TECHNICAL BULLETIN

ZF Automatic Transmission – Noise in Reverse After Cold Start in Cold Weather – Repair Procedure

44-25

MODEL All (4.0L)

ILLUSTRATION 1

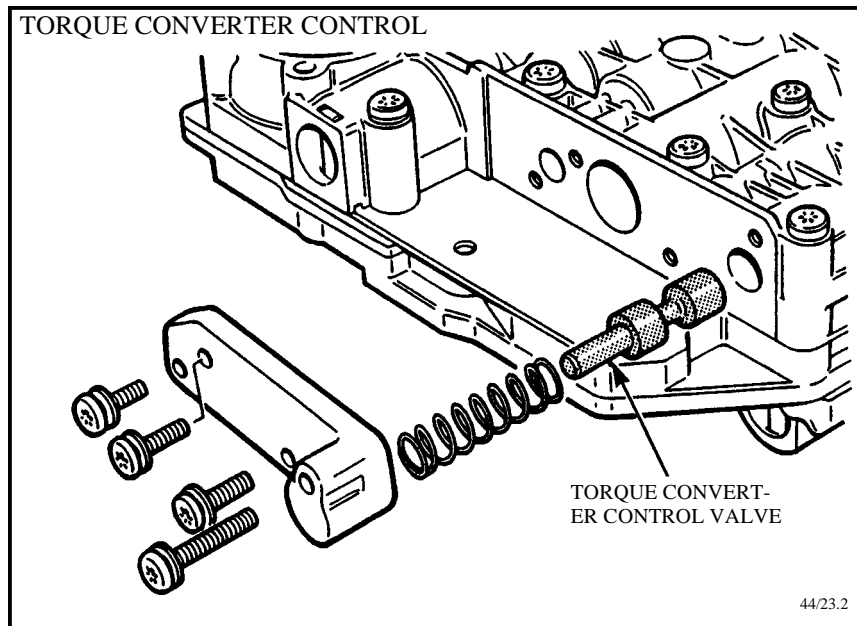
5. Remove the 4 screws shown in Illustration 1. Replace the existing torque converter control valve with a new control valve (part number NHD 5602AA).

6. Remove the 4 screws shown in Illustration 1 above. Replace the existing torque converter control valve with a new control valve (part number NHD 5602AA).
